Contract #: 04-0120F4Cty: SF/ALA Rte: 80 PM: 13.2/13.9File #: 69.25B**QUALITY ASSURANCE -- NON-CONFORMANCE REPORT****Location:** Changxing Island, Shanghai, P.R. China**Report No:** NCR-000842**Prime Contractor:** American Bridge/Fluor Enterprises, a JV**Date:** 19-Sep-2010**Submitting Contractor:** Zhenhua Port Machinery Company, Ltd (ZPMC), Changxing Island**NCR #:** ZPMC-0804**Type of problem:**

**Reference Description:** East Tower Lift 3: Missed MT Crack at 109m**Description of Non-Conformance:**

**Job Name:** SAS Superstructure

**Subject:** NCR No. ZPMC-0804

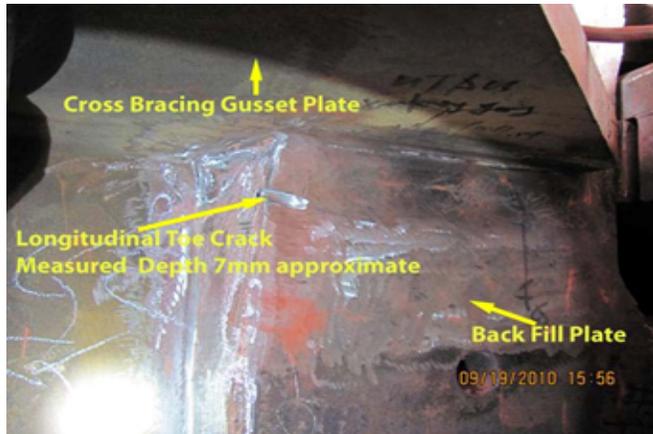
During the Quality Assurance Magnetic Particle Testing (MT) review of welds located on North Tower Lift-3, this Quality Assurance Inspector (QA) discovered the following issue:

- One (1) longitudinal toe crack indication on the weld identified as NSD1-FASA3-1B/E-29.
- The weld is a Complete Joint Penetration (CJP) weld T-joint, joining the Cross Bracing gusset plate to Back fill Plate.
- Details of the indication are as follows:  
 Length = 16mm approximately  
 Y location = 0 mm from the Cross Bracing gusset Plate  
 X location=22mm.

The indication is clearly marked on the material.

- Quality Control (QC) elected to remove the crack by grinding. QA inspector performed MT during grinding and observed the crack had disappeared at a depth of approximately 7mm and would require repair by welding.
- North Tower Lift-3 is located at Heavy dock, Tower Trial Assembly .
- The Notice of Witness Inspection Number (NWIT) is 06717.
- This weld is within an area previously tested and accepted by ZPMC (QC) personnel. ZPMC's QC personnel are required to perform 100% MT inspection of these welds.

For further information, please see the pictures below.

**Reference Resolution:** ZPMC has repaired the missed indication and is providing the CWR and NDT performed after the repair to show the weld is acceptable.

This proposed resolution is acceptable. The documentation received is sufficient and the Department concurs that Non-Conformance ZPMC-0804 is closed.

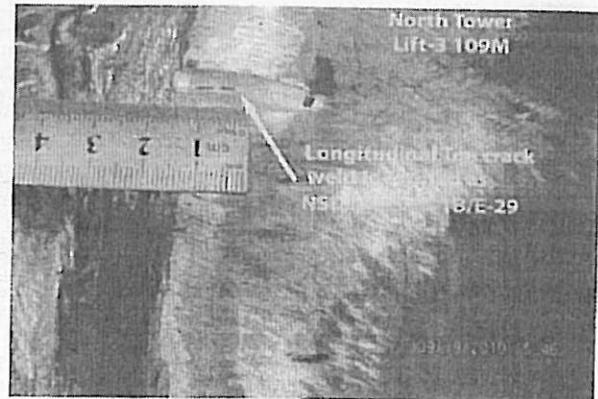
During the Quality Assurance Magnetic Particle Testing (MT) review of welds located on North Tower Lift-3, this Quality Assurance Inspector (QA) discovered the following issue:

-One (1) longitudinal toe crack indication on the weld identified as NSD1-FASA3-1B/E-29.

-The weld is a Complete Joint Penetration (CJP) weld T-joint, joining the Cross Bracing gusset plate to Back fill Plate.

The indication is clearly marked on the material.

-Quality Control (QC) elected to remove the crack by grinding. QA inspector performed MT during grinding and observed the crack had disappeared at a depth of approximately 7mm and would require repair by welding.

Contractor proposes to repair the missed indication with an approved CWR, and provide NDT documentation showing weld is acceptable. An internal NCR will be issued by the Contractor to discipline and potentially remove personnel for repeat incidents.

Contractor repaired the missed indication with an approved CWR and submitted NDT documentation support with acceptable results. An internal NCR was issued to document this incident and the personnel involved.

WELD NUMBER NSD1-FASA3-1B/E-29

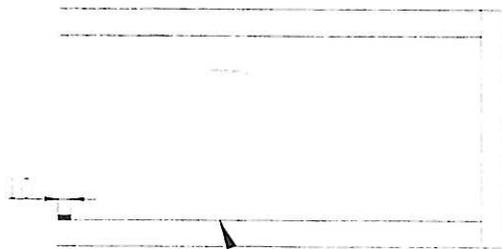
裂纹返修

Crack repair

1. 火焰加热时, 水汽没有完全的去掉或者这个区域预热不够;
1. Moisture wasn't completely removed during drying operation (preheating) or the area wasn't preheated sufficiently.

1. QC and a Lead CWI shall be present, direct and supervise all grinding and welding operations during this repair to ensure the repair is per the disposition requirements.

2. QC and a Lead CWI shall have an approved copy of the CWR in hand prior to the repair.
3. Remove paint ≥25mm in all direction of HAZ prior to MT.
4. Clean the excavation area of all loose debris including MT powder. Preheat to 65° C before removing cracks by grinding and it applied to all the repair process. Repair area shall extend a minimum of 50mm beyond each end of single crack repairs, and 50mm beyond the outermost cracks for multiple crack repairs.

1. QC shall verify sufficient preheat has been applied, to remove moisture, prior to welding.
